# Product Change Notification

PCN22-12\_ JS Series\_25 PNs: Movable Contact Design Change

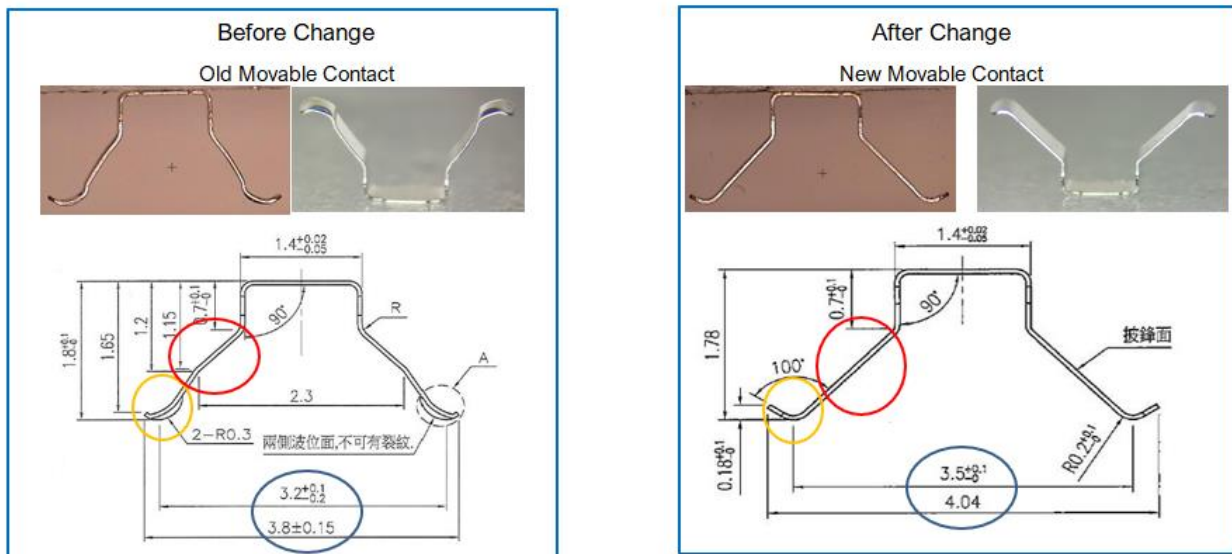
This change indicates new design of the stamping mould for the movable contact to replace the old one.

3 major design changes to the contact plate as illustrated below. All tests have been passed and reports are attached.

Point 1 (shown in the orange circles): The change from spherical contact to surface contact makes the contact area between the movable contact and the base (fixed contact) increase (from point contact to surface contact), which could decrease the wearing of contacts when sliding and have more stable contacts. Please refer to the life test report for this point.

Point 2 (shown in the red circles): The straight shape changed from the arc shape of the movable contact is more stable and the dimensions are more accurate to control/measure in the production process.

Point 3 (shown in the blue circles): The dimensions in the blue circles are adjusted accordingly to match the new design of the above structural changes. The travel distance between the movable contact and the base (fixed contact) should be more stable.
